Comments on AWD 15.3.6 DL-CTRL

Yang-Han Lee, Yih-Guang Jan, Hsien-Wei Tseng, Ming-Hsueh Chuang
Tamkang University (TKU)
Youn-Tai Lee, Chun-Yen Hsu
Institute for Information Industry (III)
Shiann-Tsong Sheu
National Central University (NCU)
Whai-En Chen
National Ilan University (NIU)

[In IEEE 802.16m-09/0010r1a, Section 15.3.6.3.2.3, Replaced by the following corrected text]

Figure 428—Chain of HF-A-MAP IE to HF-A-MAP symbols

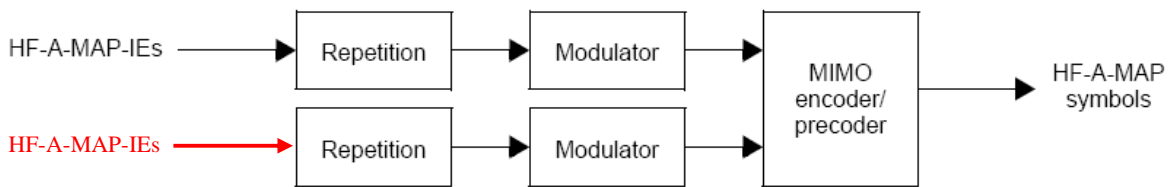
This contribution provides the corrected AWD text proposal to DL-CTRL. In Figure 428, didn't have another input signal and correct the figure.
